Response to Development Review Team Comments – 2nd Review

Project Number: RCU2024-00032

Project Name: Bondarenko Equipment Repair

Development Review Team Comments – 2nd Review

Parcel:
 0156524200001
 Site Plan

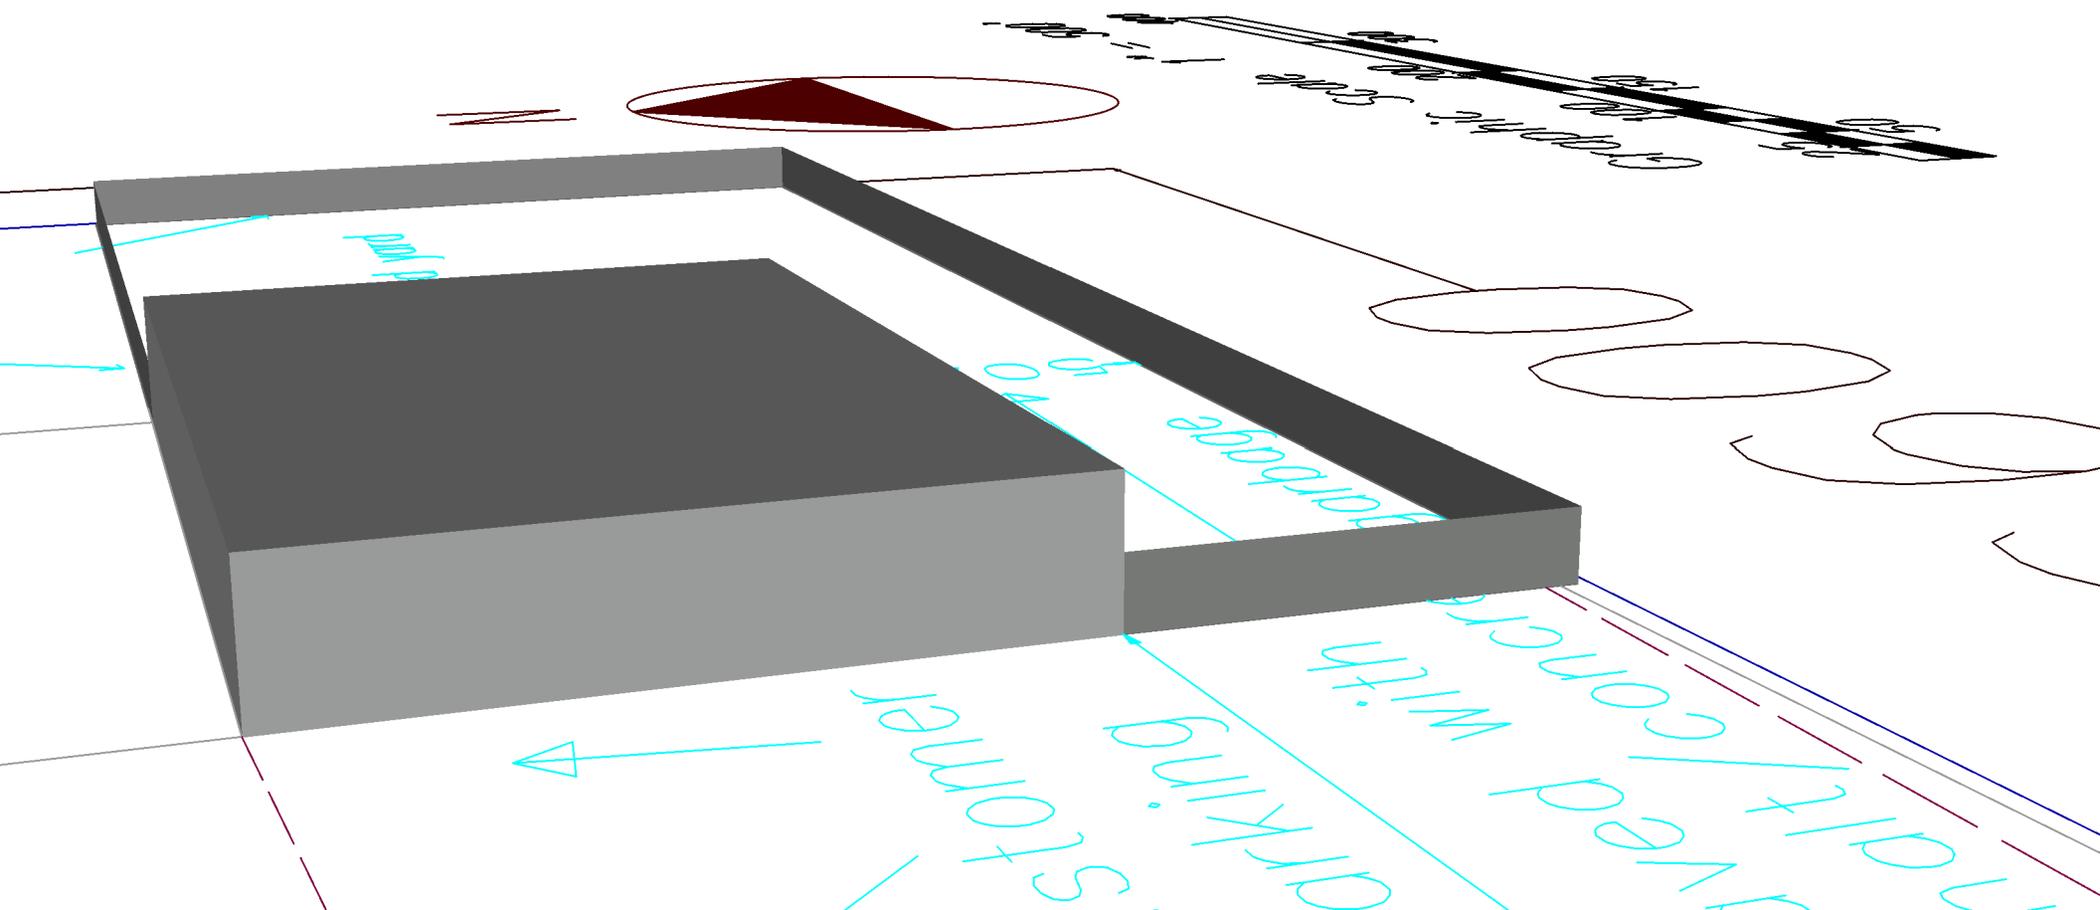
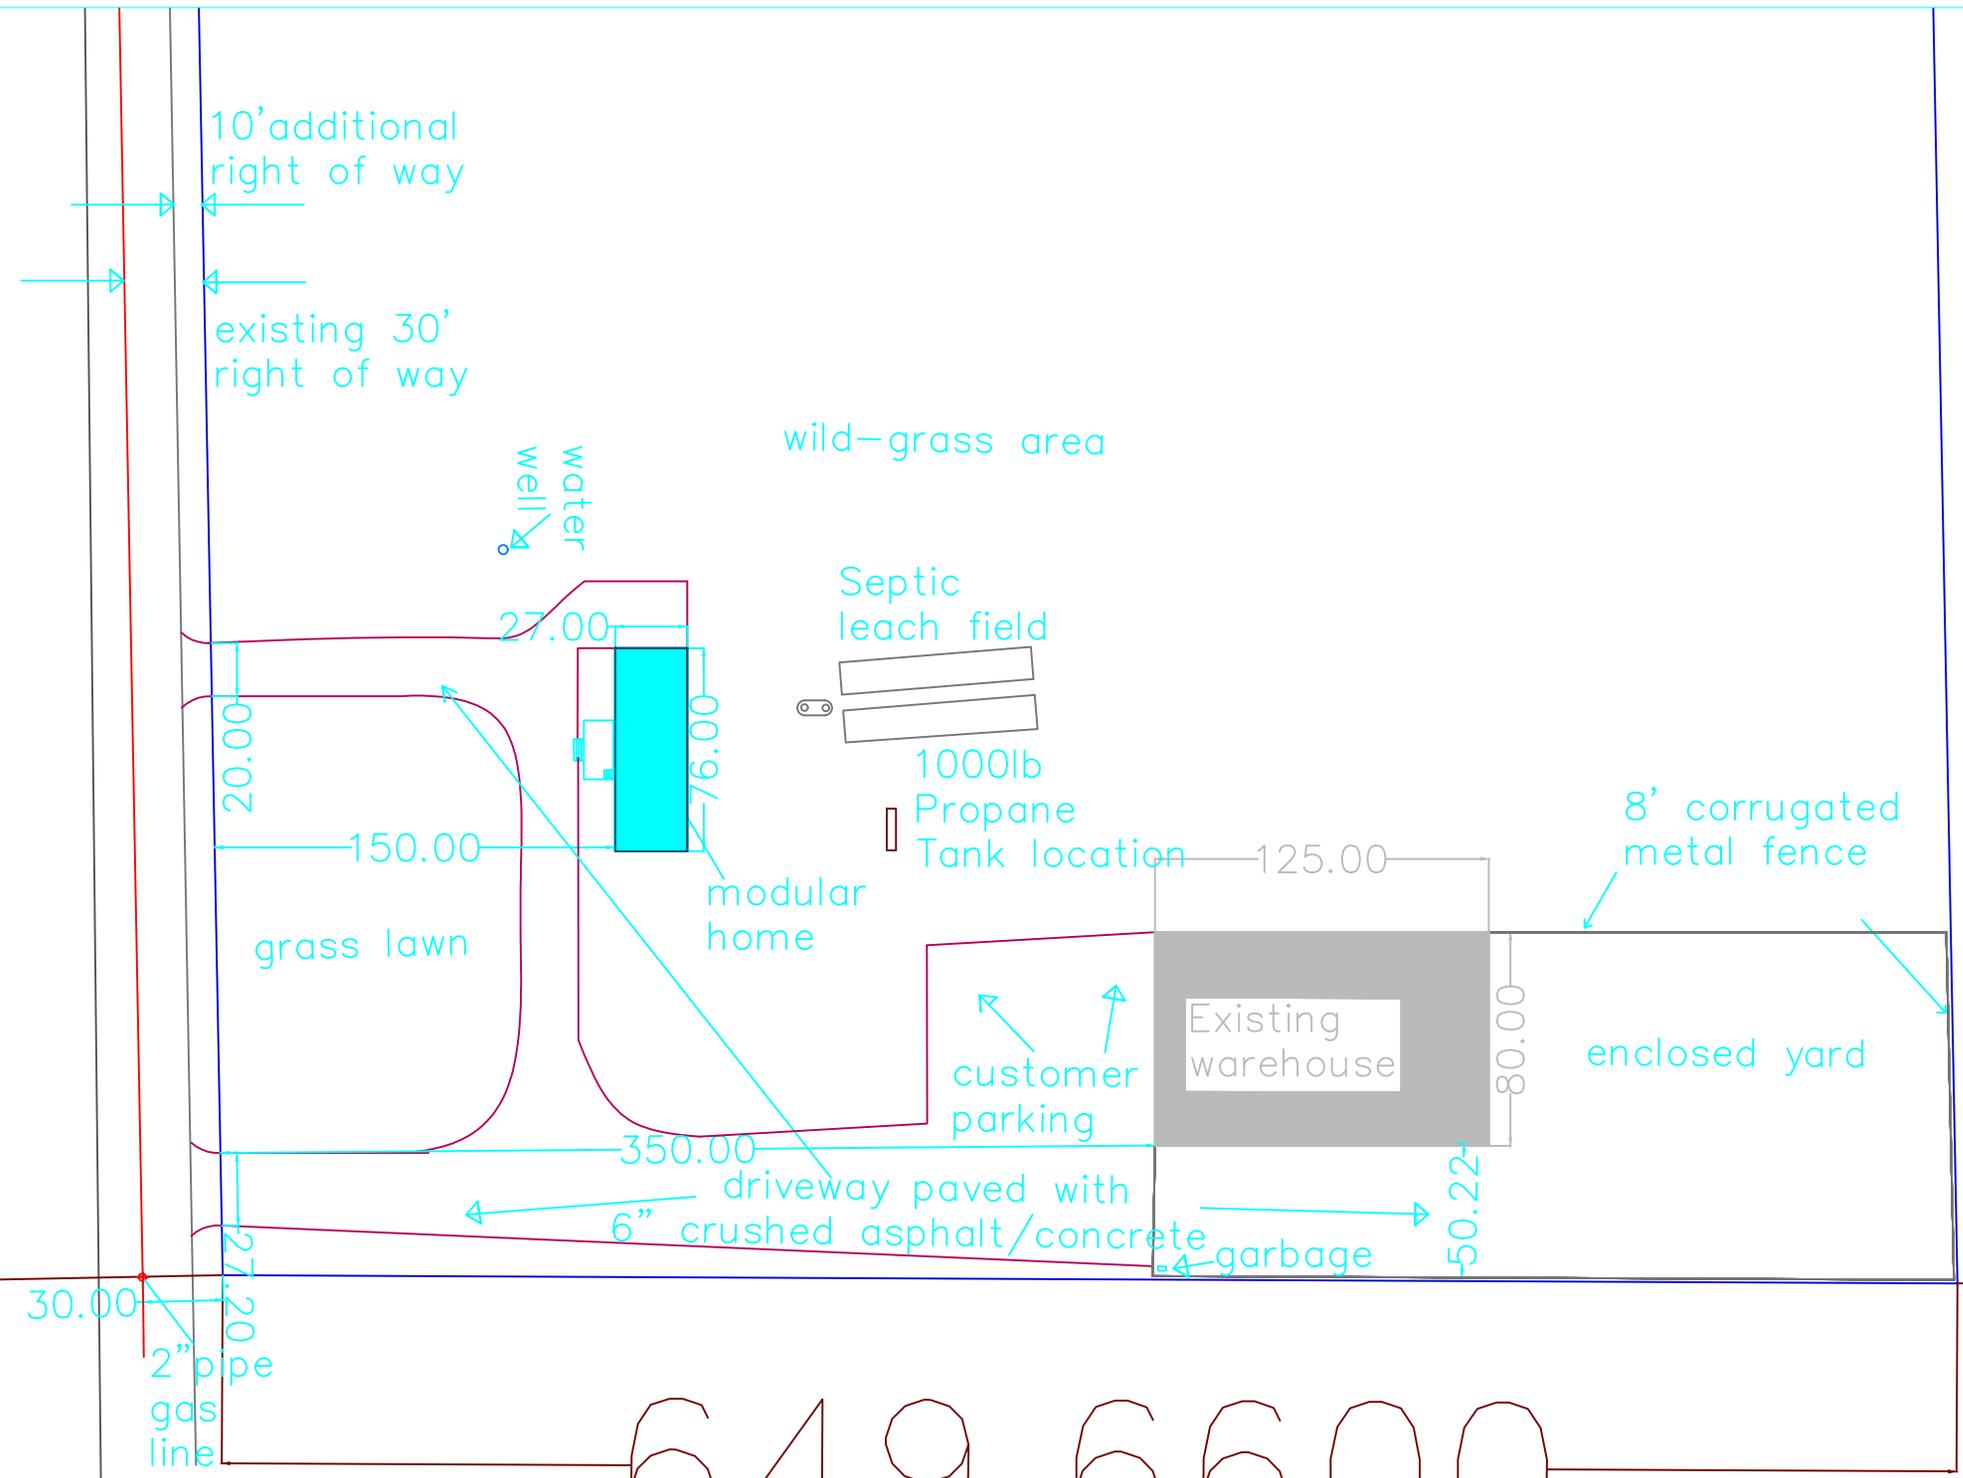
PLN05: **(Outstanding Comment)** Provide elevations for the proposed fence that will be used to conceal the parked vehicles. Please include all dimensions as part of the elevations per Sec. 4-11-01-03-07 Screen Fencing.

Planner Response: This information does not appear to be included in the resubmittal. The applicant must provide elevations of the proposed fence to ensure compliance with county standards.

PLN06: **(Outstanding Comment)** Per section 4-11-01-03-08 Garbage Area Screening, “Garbage area screening shall consist of a six (6) foot high minimum screen fence made of wood or masonry material. Fencing materials should be cleaned and maintained at all times to present an orderly appearance. No garbage storage area shall be located within twenty (20) feet of a public sidewalk.” As part of your revised site plan, please include the area designated for garbage disposal and include elevations with their corresponding elevations for the proposed fence.

Planner Response: (Outstanding Comment) The revised site plan does not show the location of the garbage area. Additionally, the resubmittal does not include elevations or details on the fence material.

PLN05: The fence is an 8' height corrugated metal fence shown on plan and elevation. Fence starts from the front / south side of the warehouse extending to the farthest east point on property, and back to north east-corner of the warehouse.

PLN06: Garbage is stored behind 8' corrugated metal fence on south side of warehouse.

FOUNDATION PLAN
SCALE: N.T.S.

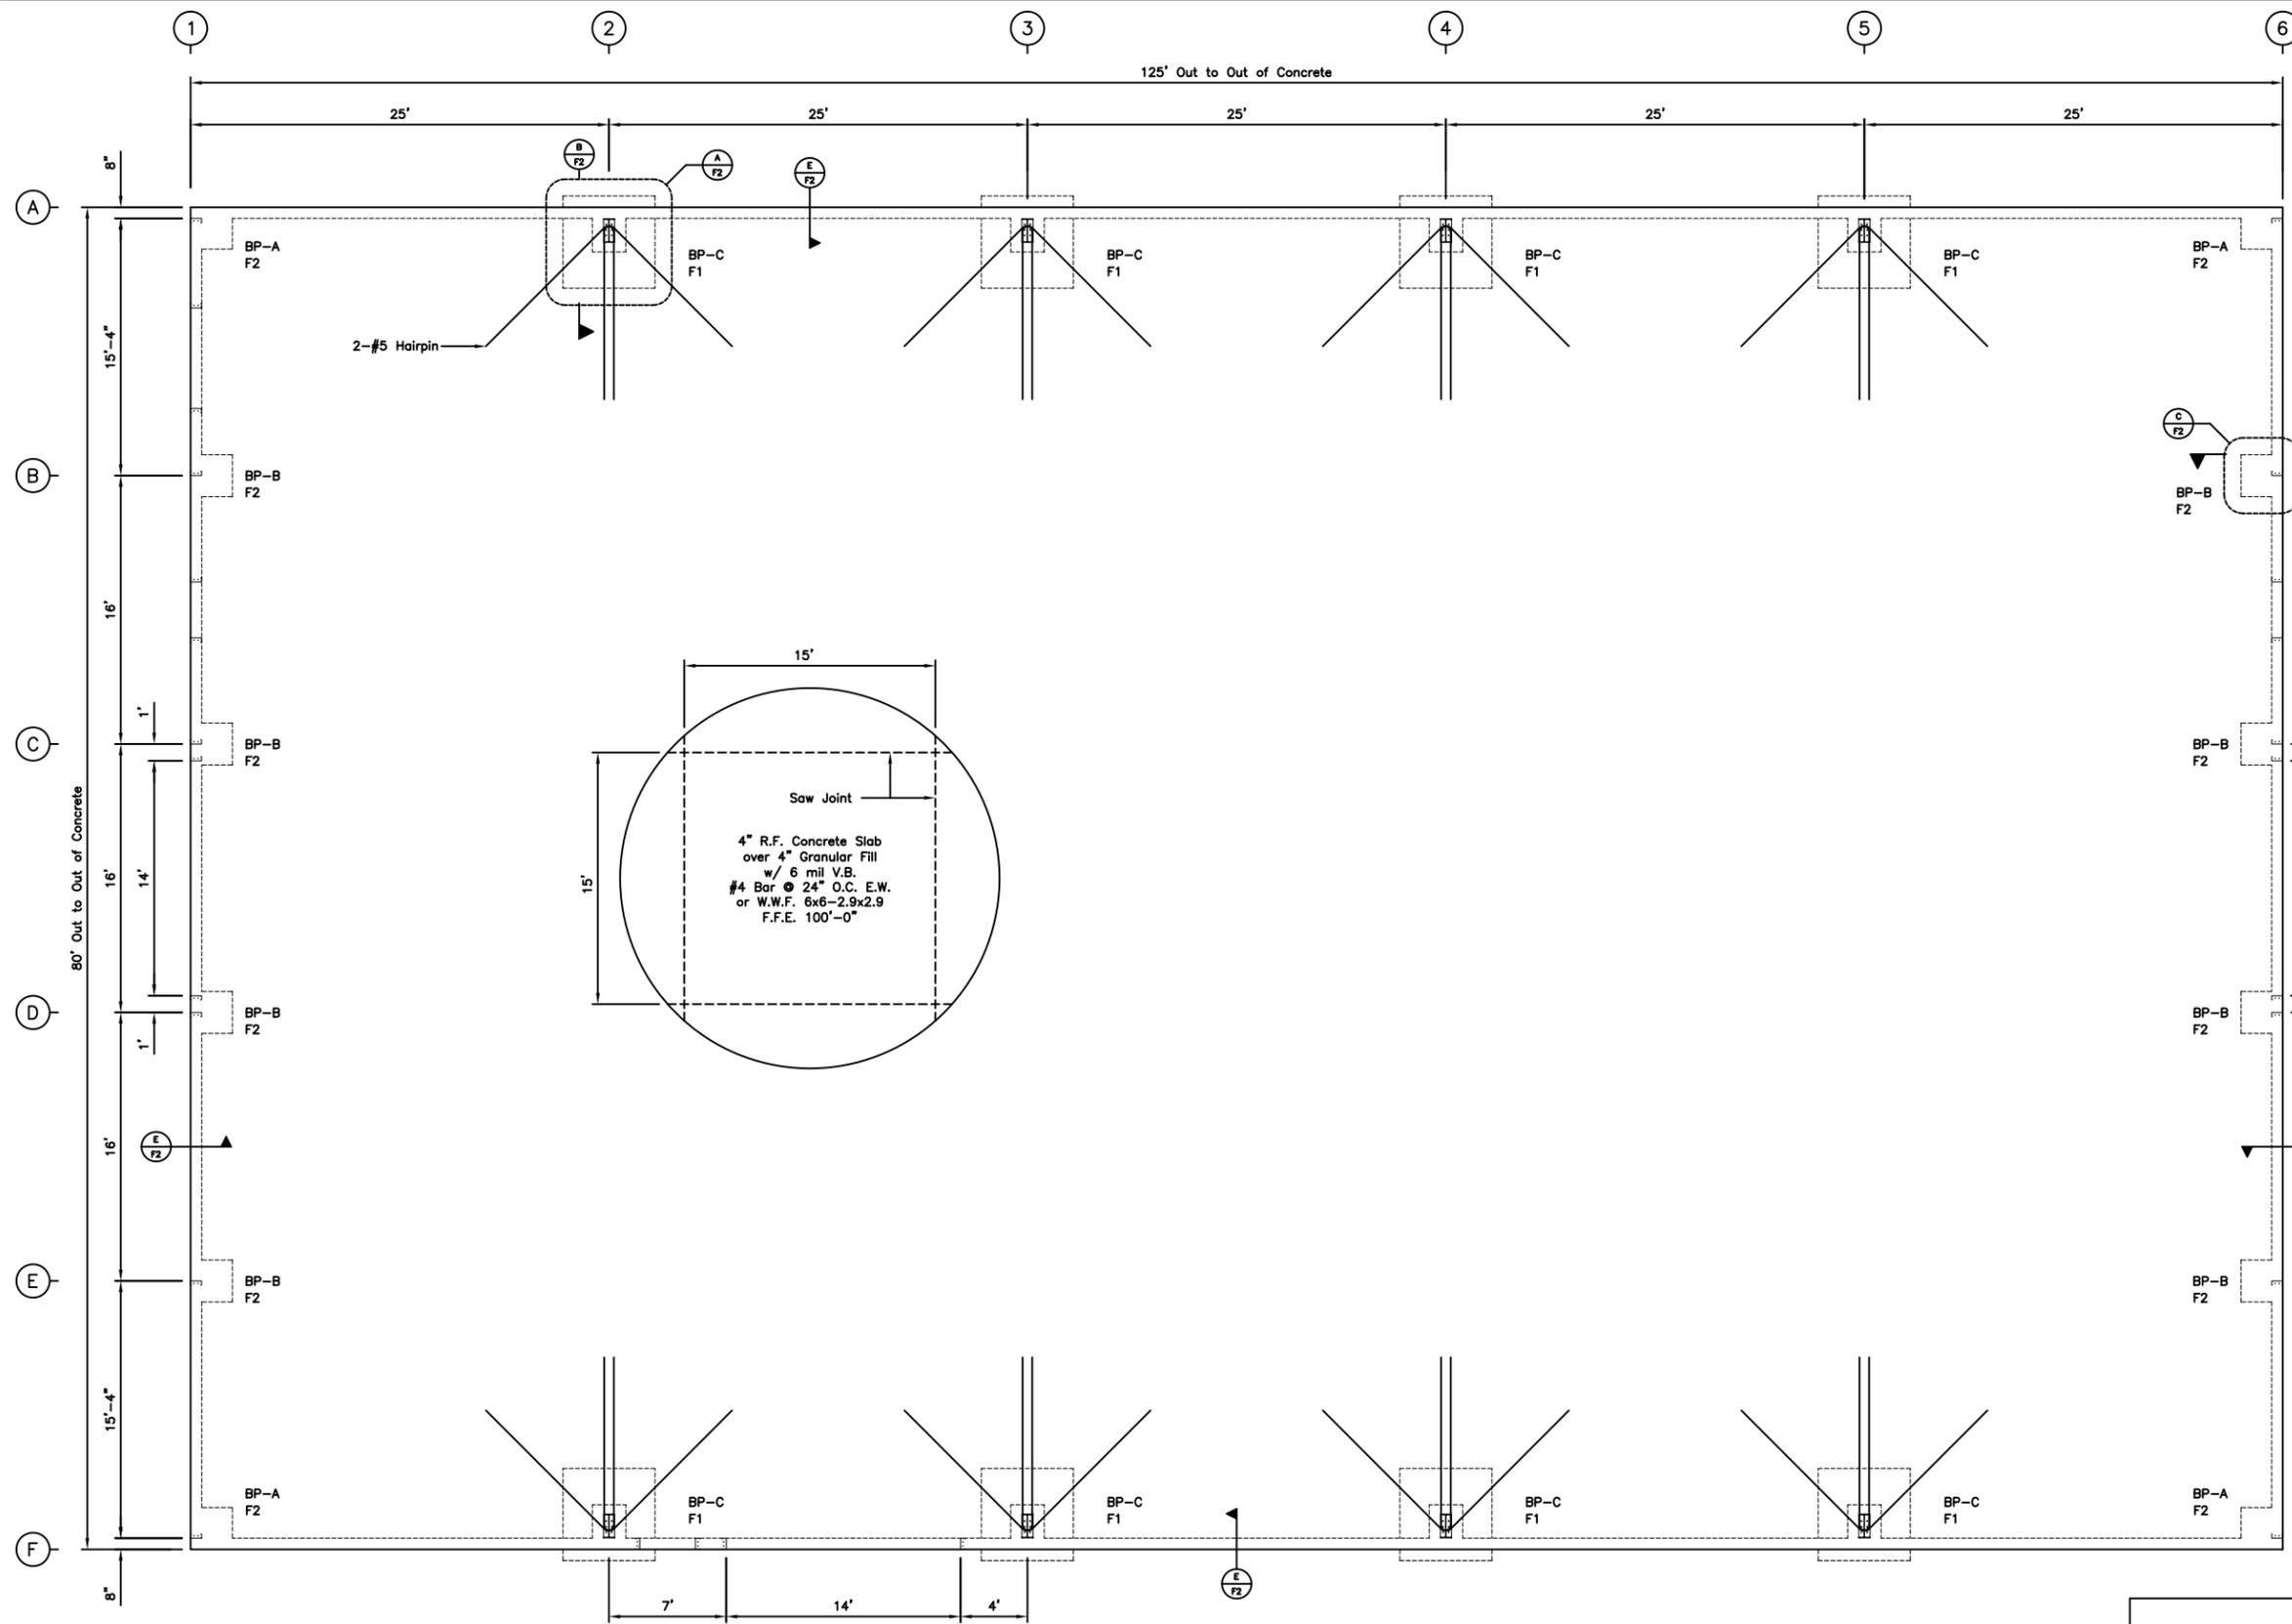
PLN07: **(Outstanding Comment)** Please provide a layout of the interior of the warehouse to understand how this facility operates. Be sure to include all bays and their use.

Planner Response: (Outstanding Comment) The resubmittal does not include an interior layout of the warehouse. The applicant must provide a formal layout with the next submittal.

PLN07: SEE ATTACHED WAREHOUSE PLAN. It is an open floor plan warehouse as was already submitted and approved with Adams county Building permit for this warehouse.
